Economic Commission for Europe**Inland Transport Committee****World Forum for Harmonization of Vehicle Regulations****Working Party on Lighting and Light-Signalling****Seventy-ninth session**

Other Regulations:**Regulation No. 10 (Electromagnetic compatibility)****Proposal for the 06 series of amendments to Regulation
No. 10 (Electromagnetic compatibility)****Submitted by the Task Force on Electromagnetic Compatibility (TF
EMC)***

The text reproduced below was prepared by TF EMC with the aim to make Regulation No. 10 consistent with the International Special Committee on Radio Interference (CISPR) 12 Standard vehicle narrow-band limit and the last CISPR 12 set-ups (artificial networks, harness location, Z-folding, ...) for vehicles in charging mode. It also includes precision for vehicle in charging mode operating conditions (alternative or direct current charging). The modifications are marked in bold for new or strikethrough for deleted characters.

Appendix 4,

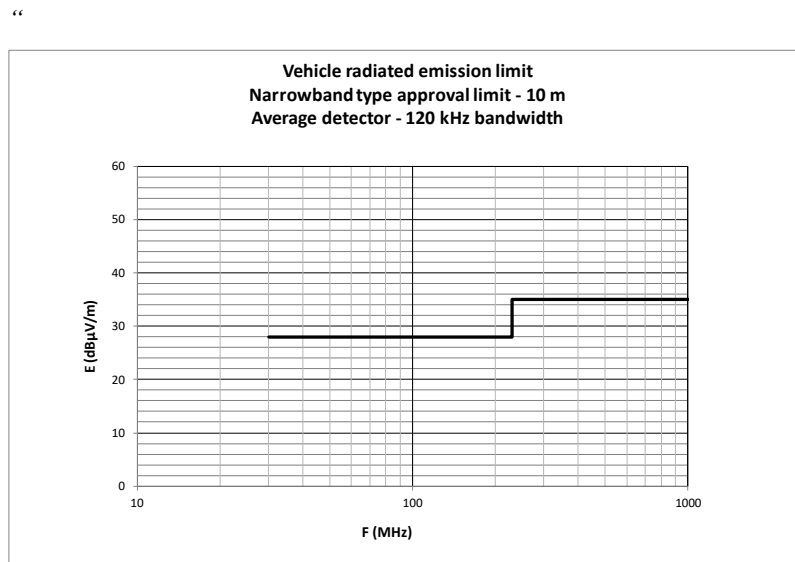
Table, amend to read:

<i>Limit E (dBμV/m) at frequency F (MHz)</i>	
30-230 MHz	230-1,000 MHz
E = 28	E = 35

Figure, amend to read:

Appendix 5,

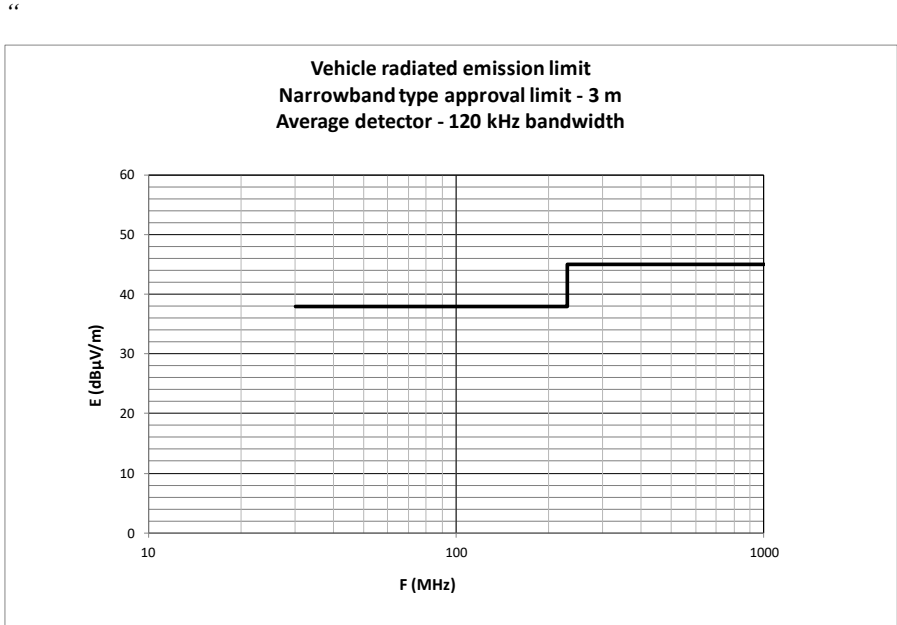
Figure, amend to read:

Frequency - megahertz - logarithmic
(See paragraph 6.3.2.2. of this Regulation)”

Figure 1
HV-AN artificial network

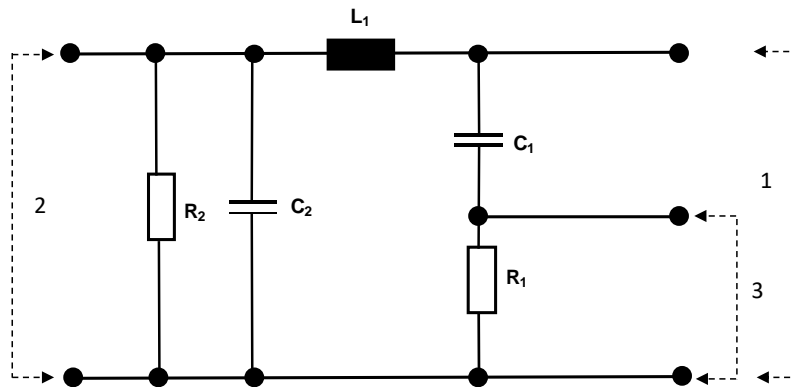
Appendix 8, amend to read:

HV artificial network

Figure 3
Combination of HV-AN artificial network

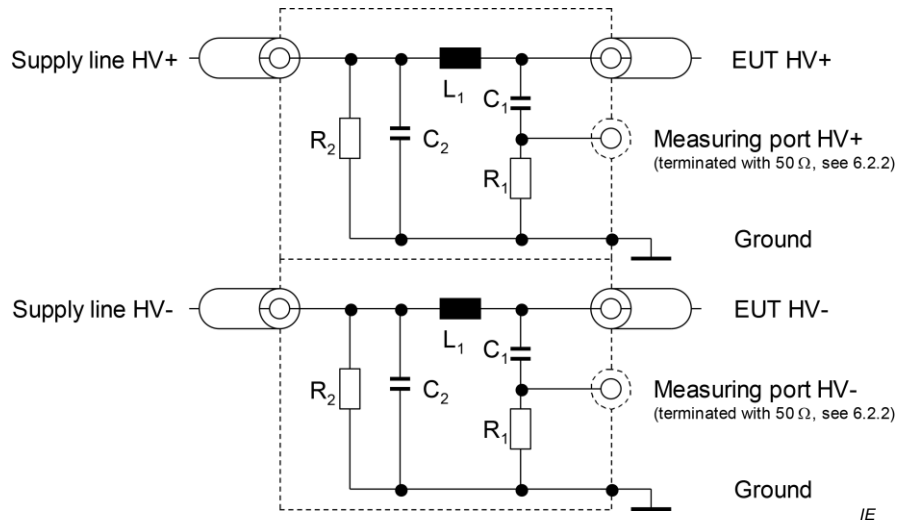
If unshielded HV ANs are used in a single shielded box, then there shall be an inner shield between the HV ANs as described in 3.

Figure 4
DC charging-AN

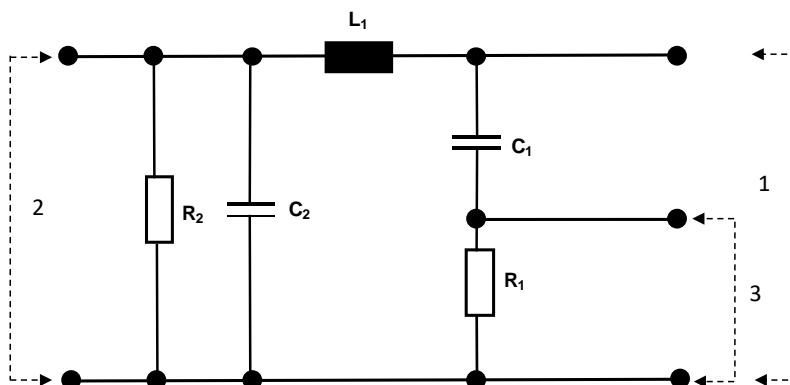
DC Power mains shall be applied to the vehicle / ESA through $5 \mu\text{H}/50 \Omega$ **HVDC-charging-AN(s)** as defined in **CISPR-25 Appendix 8.**

- L_1 5 μH
 C_1 0,1 μF
 C_2 1 μF (default value)
 R_1 1 $\text{k}\Omega$
 R_2 1 $\text{M}\Omega$ (discharging C_2 to $< 50 \text{ V}_{\text{dc}}$ within 60 s)

Figure 3
Vehicle in configuration "REESS charging mode" coupled to the power grid:
Example of test set-up for vehicle with plug located on vehicle side (AC powered without communication)

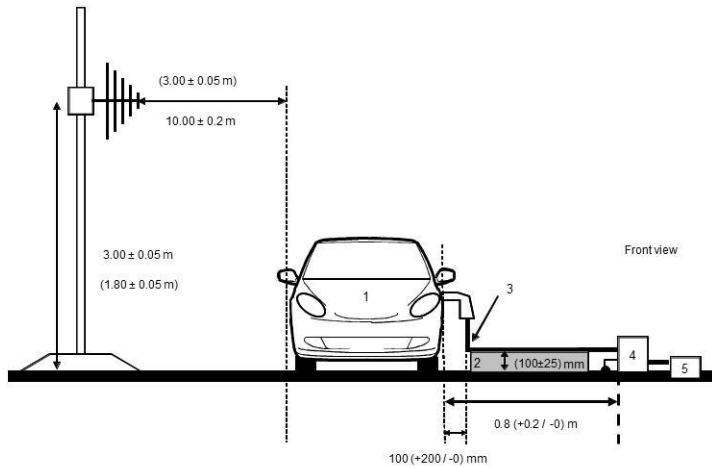
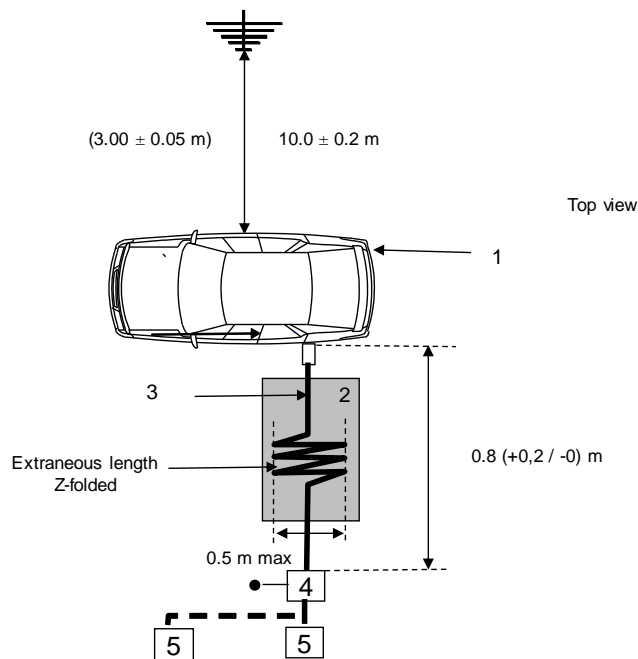
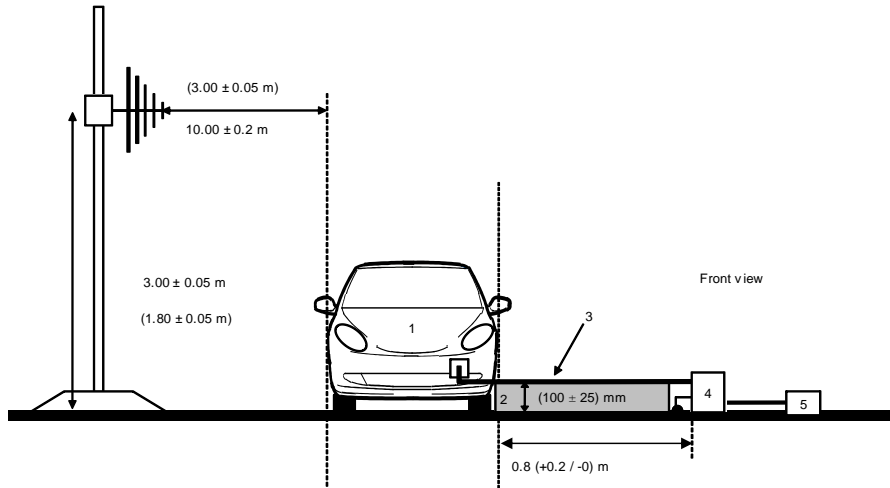
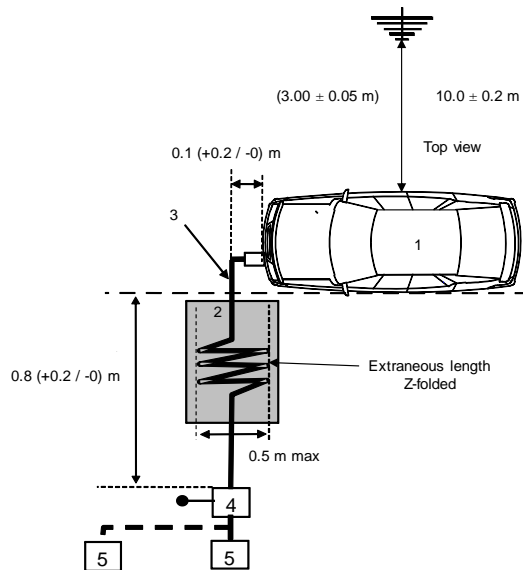
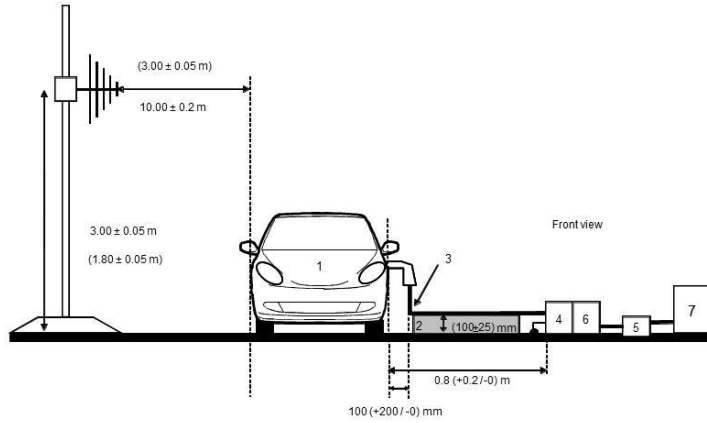
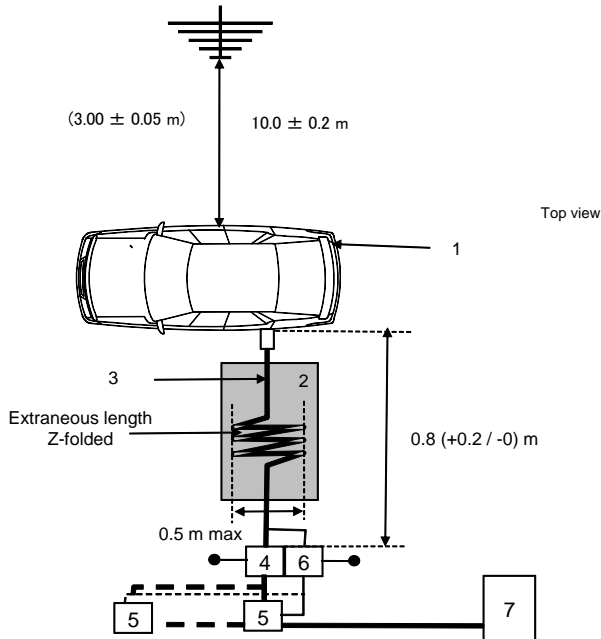
The test set-up for the connection of the vehicle in configuration "REESS charging mode coupled to the power grid" is shown in Figures 3a to 3h (depending of AC or DC power charging mode, location of charging plug and charging with or without communication) of Appendix 1 to this annex.”

The ~~AN~~ **AMN(s)/DC-charging-AN(s)** shall be placed as defined in Figures 3a to 3h.”

Annex 4, Appendix 1, amend to read:

Figure 3

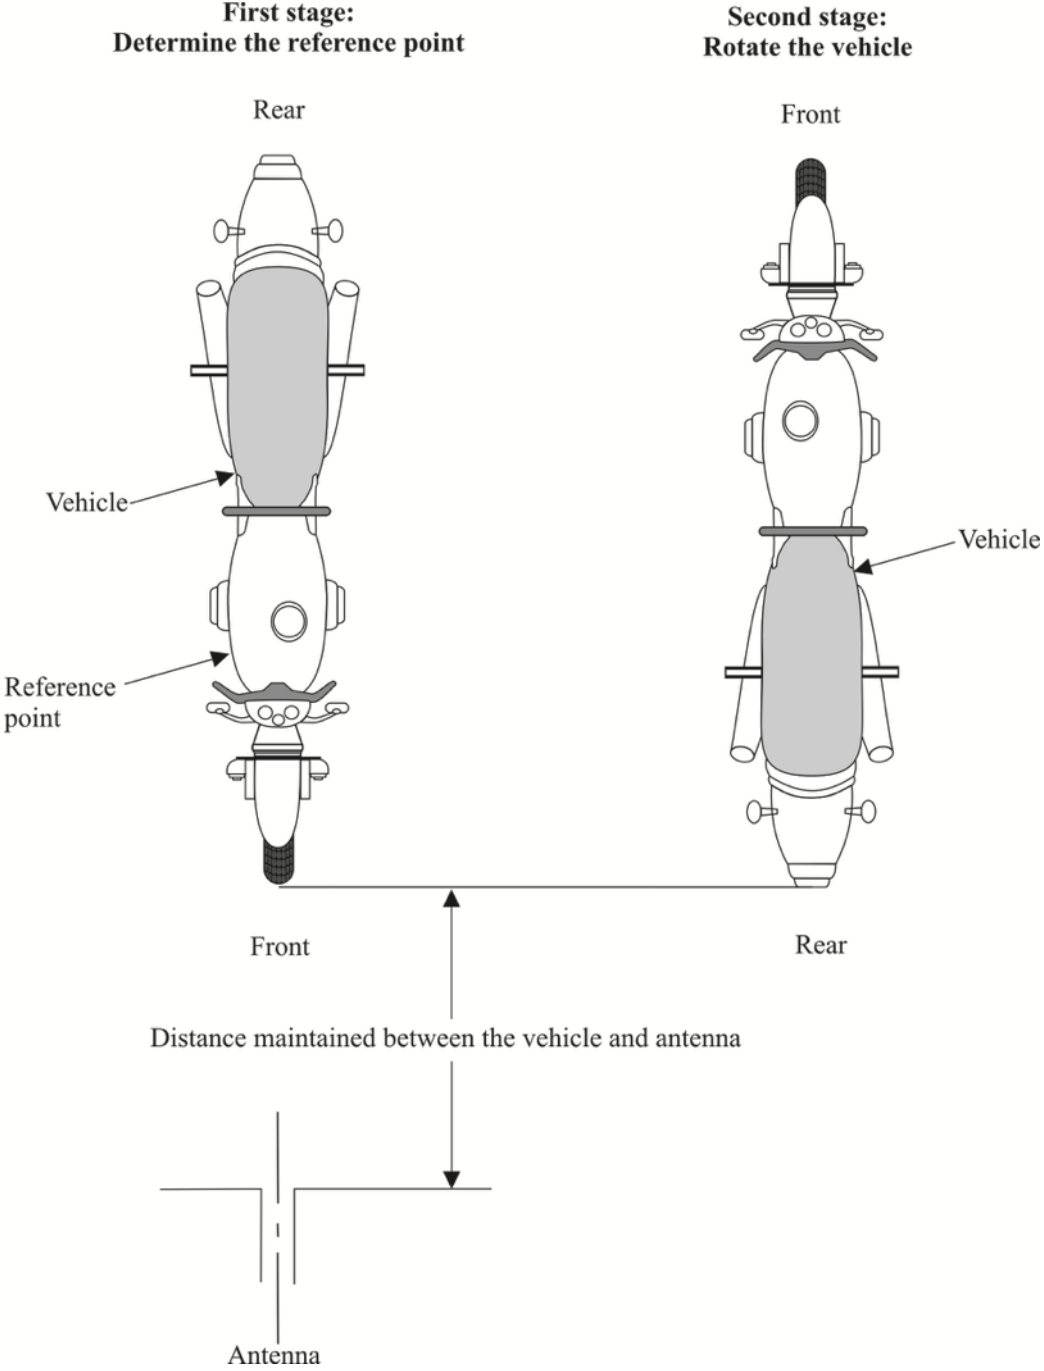
“3.3.5. If it is decided to radiate the rear of the vehicle, the reference point shall be established as in paragraphs 3.3.1. to 3.3.4. above. The vehicle shall then be installed facing away from the antenna and positioned as if it had been horizontally rotated **180°** around its centre point, i.e. such that the distance from the antenna to the nearest part of the outer body of the vehicle remains the same. This is illustrated in Figure 3 of Appendix 1 to this annex.”

Figure 4

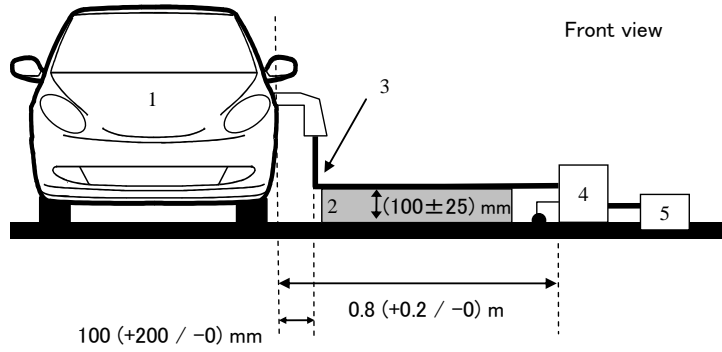
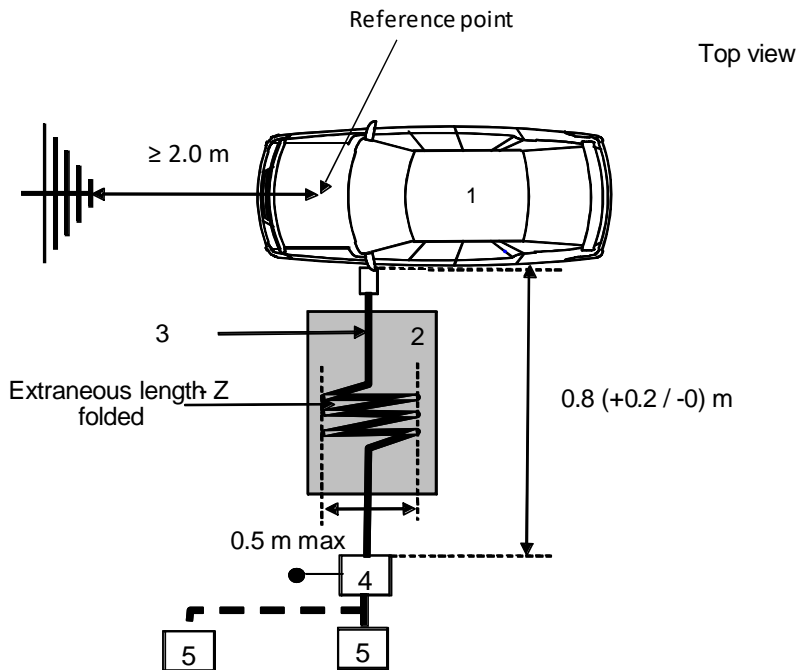
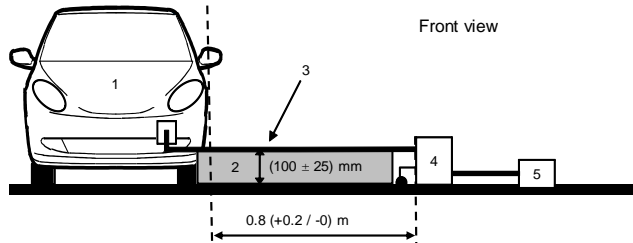
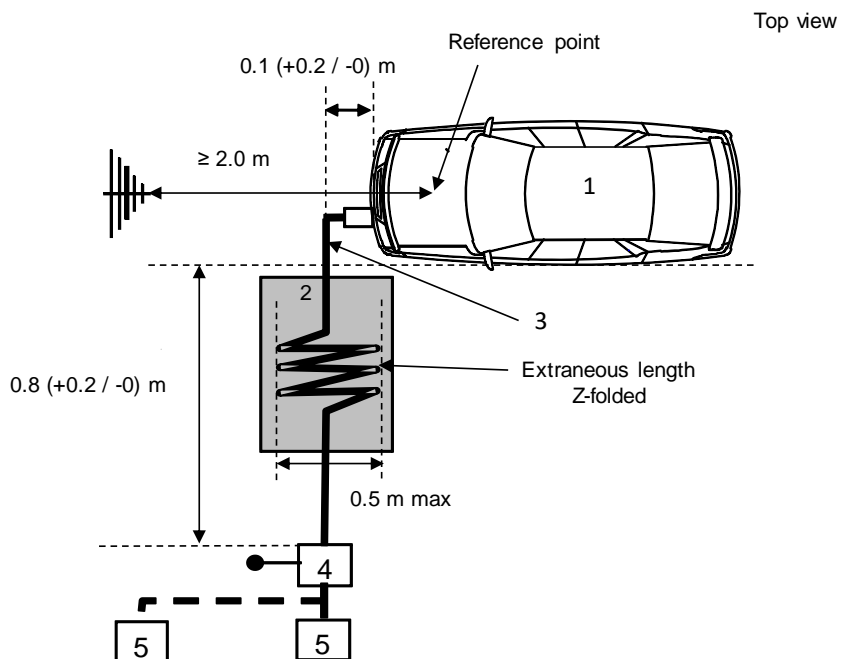
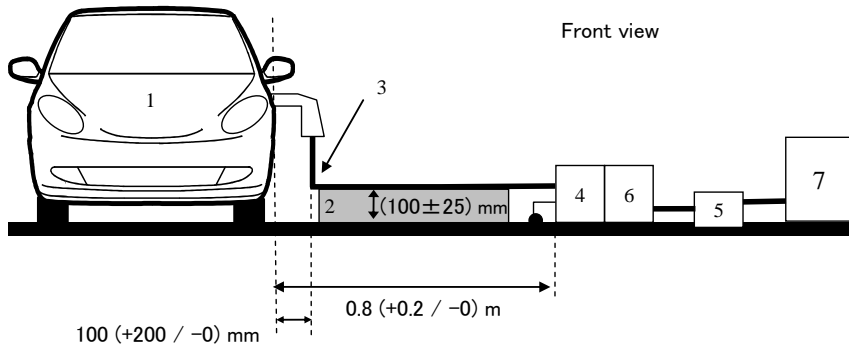
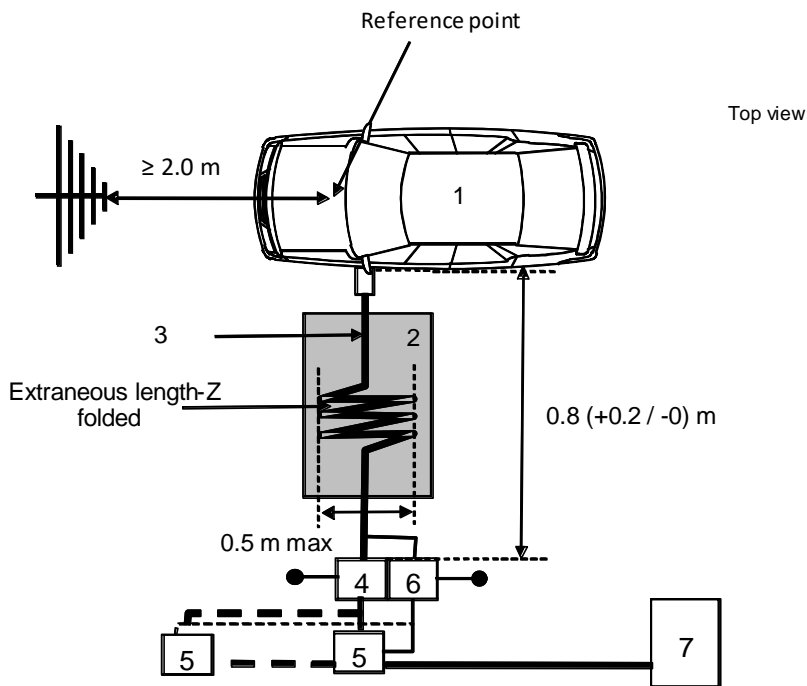
The ~~AN~~ **AMN(s)/DC-charging-AN(s)** shall be placed as defined in Figures 4a to 4h.”

Figure 1
Vehicle in configuration "REESS charging mode coupled to the power grid"

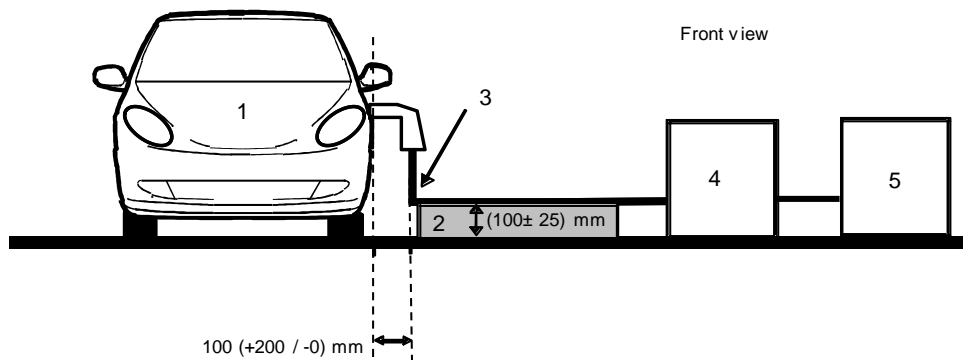
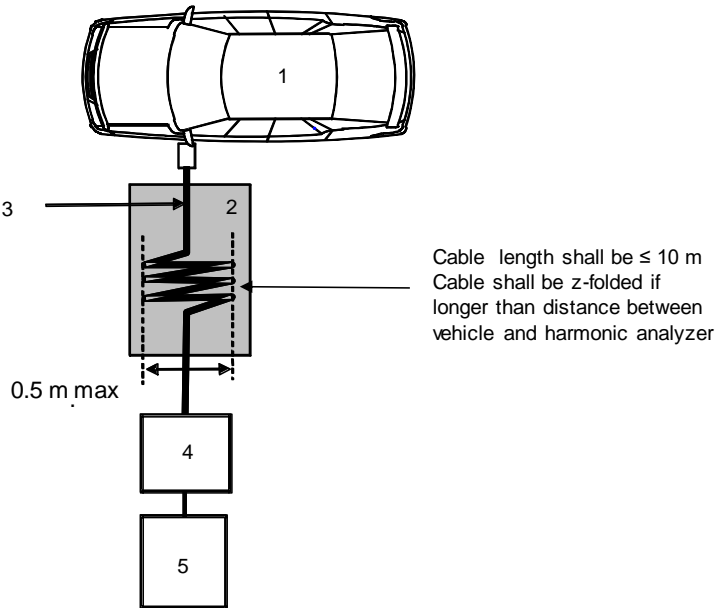
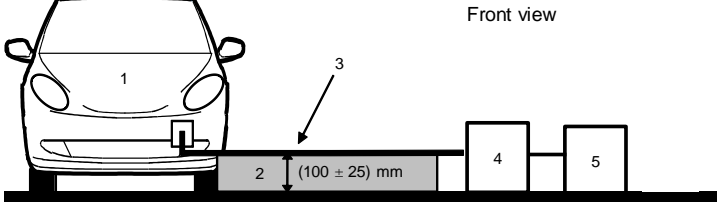
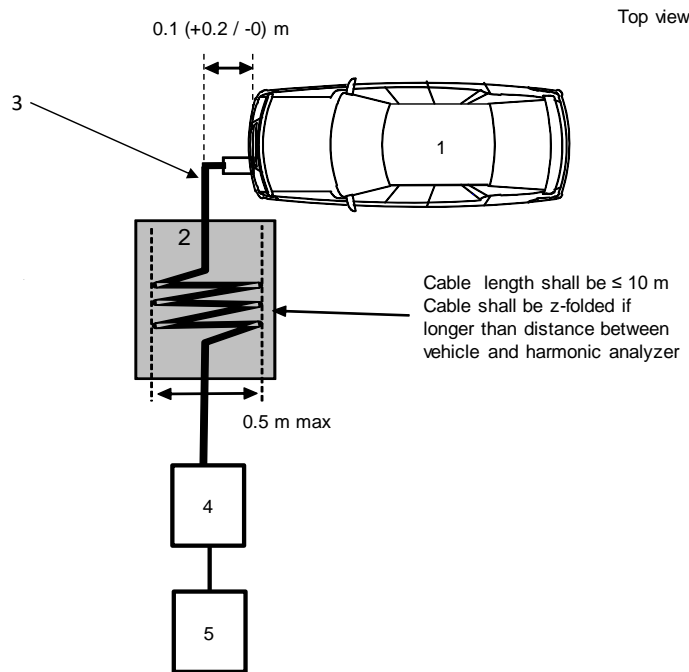
“3.2. The test set-up for single phase / **three-phase** vehicle in configuration "REESS charging mode coupled to the power grid" is shown in Figure 1a to 1d of Appendix 1 to this annex.”
